**ADDENDUM TO THE FINAL ENVIRONMENTAL IMPACT
REPORT – TENTH AVENUE MARINE TERMINAL
REDEVELOPMENT PLAN AND DEMOLITION AND
INITIAL RAIL COMPONENT PROJECT
SCH No. 2015-031046**

JULY 2017

Figure 2: Site Plan showing changes to Demolition and Initial Rail Component Project

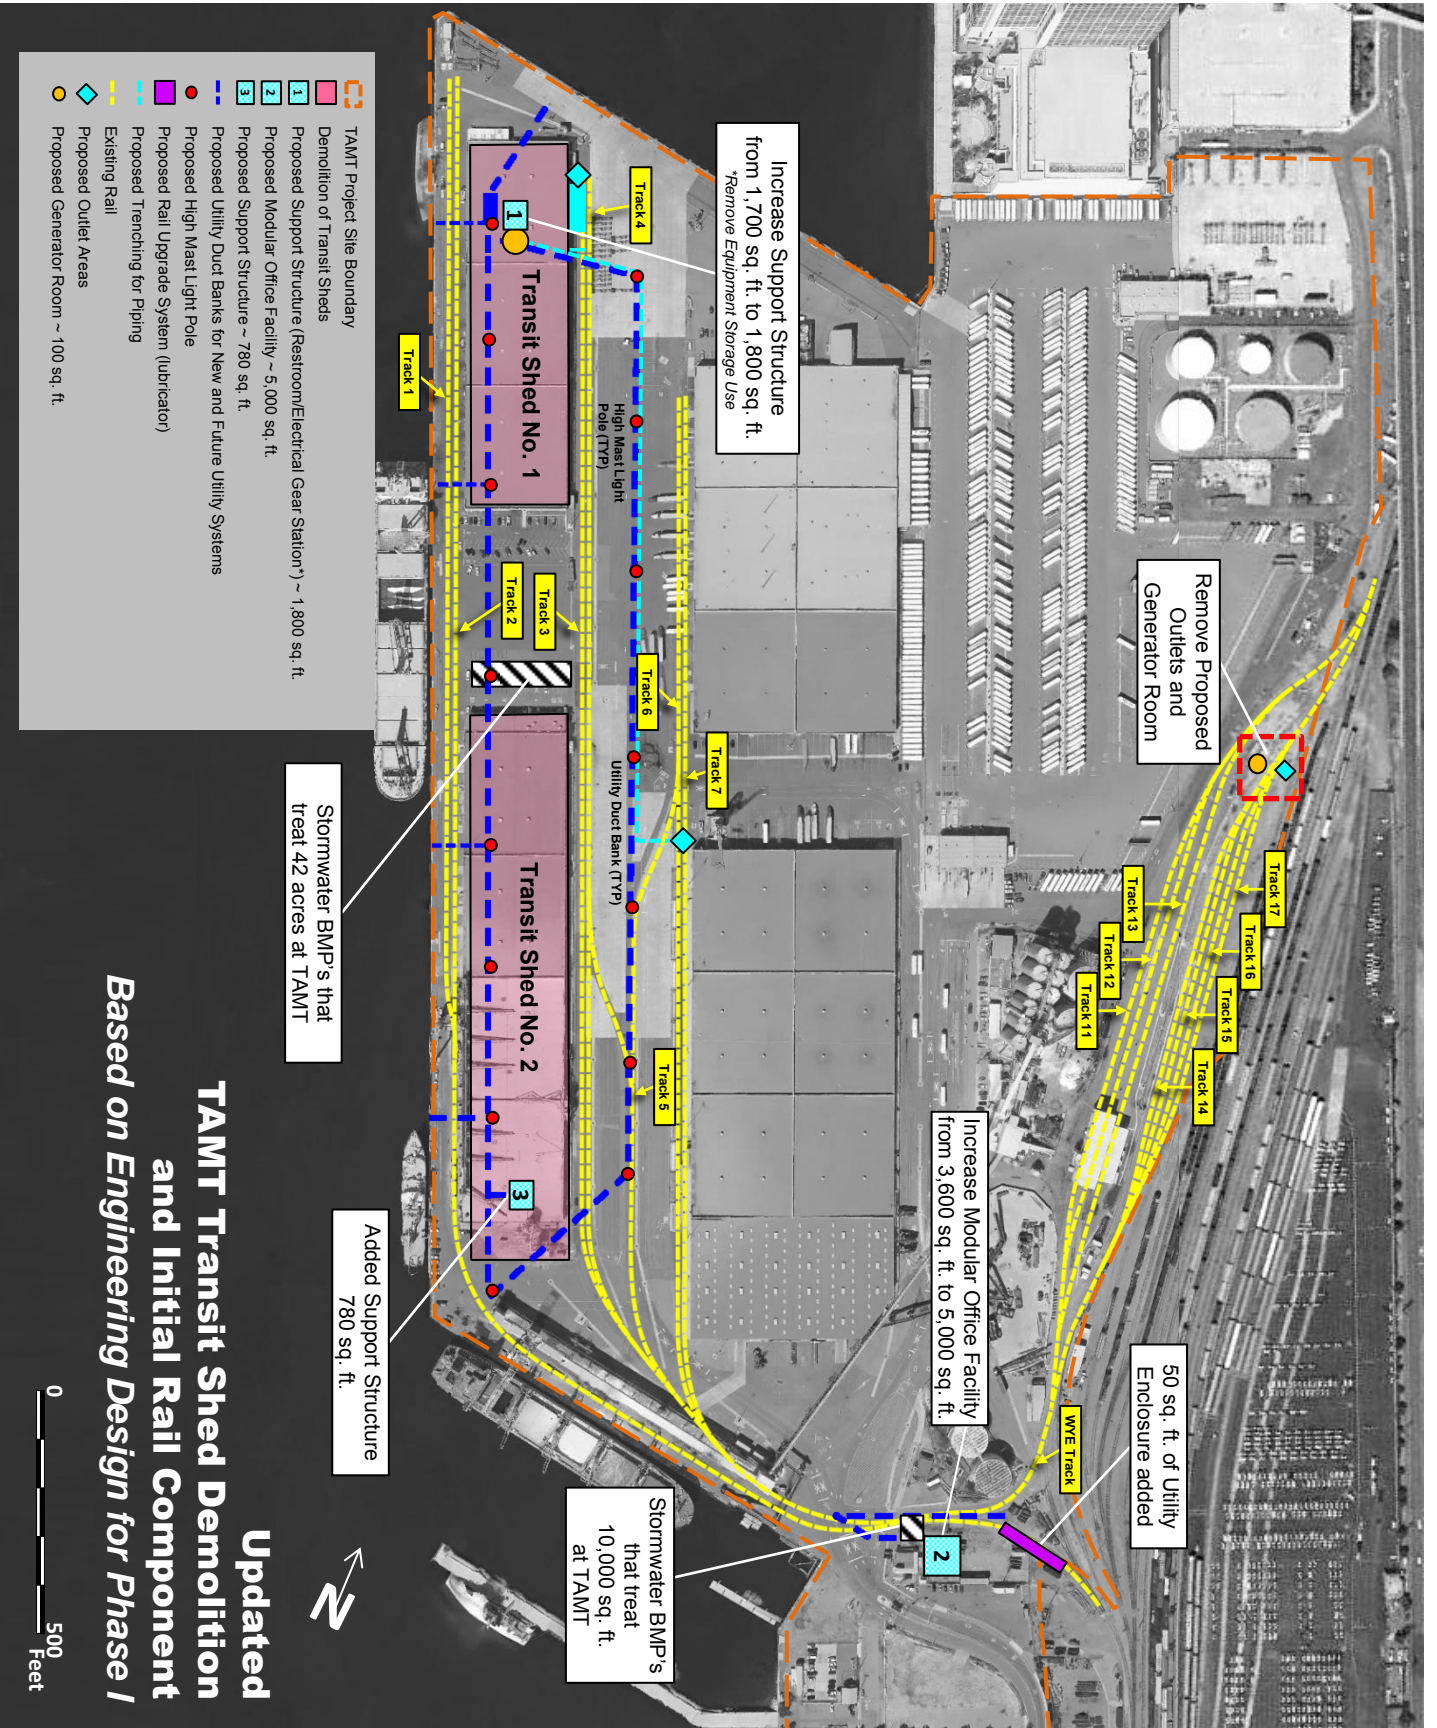
As a result of final engineering design work that was completed for the first Phase of the Project in May 2017, the updated Demolition and Initial Rail Component (updated Project or updated Demolition and Initial Rail Component Project) results in an increase of onsite, above-grade improvements. In particular, the proposed updated Project includes approximately 7,630 square feet of above-ground improvements which is 2,348 square feet larger than the improvements proposed by the original Project. . The specific modifications that are being proposed to the updated Project are summarized below and shown on Figure 2 – Site Plan Showing Changes to the Demolition and Initial Rail Component on page 17.

1. **Modular Office Building:** The Final EIR analyzed the environmental impacts of a 3,600 square foot temporary modular office facility. As revised, the modular office would become permanent and would increase in size by 1,400 square feet, resulting in a 5,000-square-foot facility.
2. **Support Structure(s):** The Final EIR analyzed one 782-square-foot support structure that would be located where Transit Shed #1 is currently located (northern portion of terminal), which included an electrical gear room, restroom facility, and an information technology room (IT Room), as well as an attached 850-square-foot outdoor equipment storage area. As revised, the 850-square-foot outdoor storage area would be removed, and the support structure would be 1,800 square feet (.an approximate 750 square foot increase) of office area to accommodate existing Customs and Border Patrol (CBP)

staff. In addition, the updated Project includes a new 780-square-foot support structure that would be located where Transit Shed #2 is currently located (southern portion of terminal), which would also include an electrical gear room, restroom facility, and an IT Room. Both facilities would include exterior electrical equipment, fire hydrants, and 90-foot tall light poles, as described in the Final EIR.

3. **Subsurface Improvements:** The Final EIR analyzed impacts associated with installing one of two potential stormwater drainage systems. As revised, the updated Project identifies the specific stormwater system improvements that would be constructed, as well as reconfiguring water and sewer connections to reflect the final design. The revised Project reconfigures existing water and sewer systems to eliminate connections to Transit Sheds #1 and #2, and it provides new connections to the two support structures and the new modular office building located near the terminal's entry gate. The new stormwater system includes BMP pass-through filtration systems that will be installed in two areas. The first system will be located between Transit Sheds #1 and #2 and treat 42-acres of runoff area in the main outfall pipe. The second system will be located near the new modular office and designed to treat an area approximately 10,000-square-feet. The BMP pass-through filtration systems would still include necessary features to capture the 85th percentile stormwater event, as analyzed in the Final EIR. Similarly, excavation for all subsurface improvements would continue to be 9,200 cubic yards or less, as discussed in the Final EIR.

4. **Conduit and Electrical Improvements:** The Final EIR analyzed installing up to 2,500 linear feet of conduit west of Warehouse B and C and east of existing Transit Shed #1 and Transit Shed #2 to provide for future electrification of the terminal. The precise design and location of the conduit and electric improvements is now available, which has been updated to include communication systems infrastructure and reconfigured to connect to (1) the new permanent office building, and (2) the two new separate support structures serving the northern and southern portions of the terminal. As analyzed in the Final EIR, trenching for up to 2,500 linear feet of conduit and other electrical improvements would occur prior to paving activities. The system would utilize the existing vault system and would use some existing conduit as well as some new conduit, as analyzed in the Final EIR.

would be sited along the terminal's northeastern boundary to serve tracks 14, 15, 16 and 17. As revised, the updated Project has eliminated the third airbrake system to serve tracks 14, 15, 16 and 17 because it was determined this improvement is no longer needed in this area. Additionally a 50-square-foot equipment enclosure has been added to house the rail track lubrication system, which would include a small tank and pumping system and consist of some underground piping. This structure will support the rail track lubrication system that would be located on the curved portion of the BNSF tracks at the southernmost area of the terminal (adjacent to the eastside of the molasses storage tanks).
